Access Compliance Report

Public Rights-of-Way

(Curb Ramps)

Intersection ID: 45488	Main Street: CAPTAIN_ARDREY_RD	Cross Street: GINHOUSE_LN	Location: SW
ADA ID: E361FF2723F8	Ramp Type: Perp	Initial Pass/Fail: Fail	Overall Compliance: No
Severity Score: 26.25			
Codes/Mitigation Info/Possible Solution		Field Measurements/Component Compliance

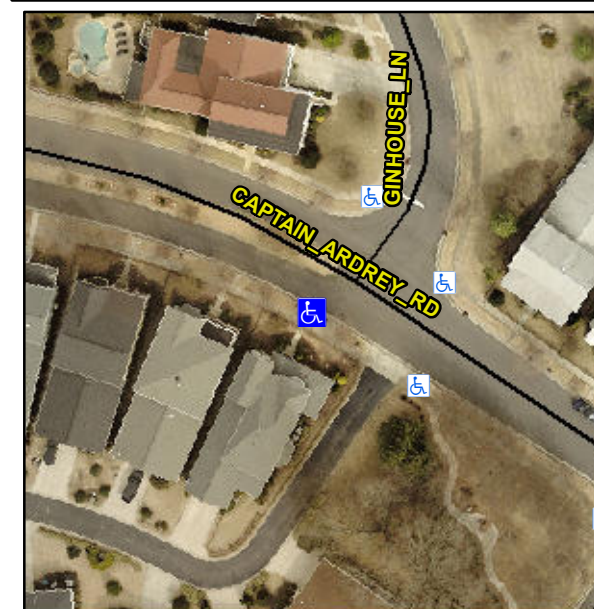
Not Found, R304.2.2

Compliance	Description	Data	Compliance	Description	Data
N/A	Ramp Length (in)	72.0	No	Ramp Slope (%)	12.1
Yes	Ramp Width (in)	48.0	Yes	Ramp XSlope (%)	3.1
N/A	Flare Type LT	N/A	N/A	Flare Type RT	N/A
N/A	Flare Slope LT (%)	N/A	N/A	Flare Slope RT (%)	N/A
N/A	Flare Traversable LT?	N/A	N/A	Flare Traversable RT?	N/A
N/A	Landing Length (in)	N/A	N/A	DWS Provided?	N/A
N/A	Landing Width (in)	N/A	N/A	DWS Contrast?	N/A
N/A	Landing Slope (%)	N/A	N/A	DWS Length (in)	N/A
N/A	Landing X Slope (%)	N/A	N/A	DWS Full Width?	N/A
N/A	Landing Curb? (Y/N)	N/A	N/A	DWS Offset (in)	N/A
N/A	Shared Landing?	N/A			
N/A	Gutter Ponding?	N/A	N/A	Gutter Slope (%)	N/A
N/A	Gutter Lip Ht (in)	N/A	N/A	Gutter X Slope (%)	N/A
N/A	Painted X Walk1?	No	N/A	Painted X Walk2?	N/A
	X Walk 1 Direction	To NE		X Walk 2 Direction	N/A
N/A	X Walk 1 Width (in)	N/A	N/A	X Walk 2 Width (in)	N/A
	X Walk 1 Slope (%)	2.4		X Walk 2 Slope (%)	N/A
	X Walk 1 X Slope (%)	3.8		X Walk 2 X Slope (%)	N/A

Remove & Replace Entire Ramp.
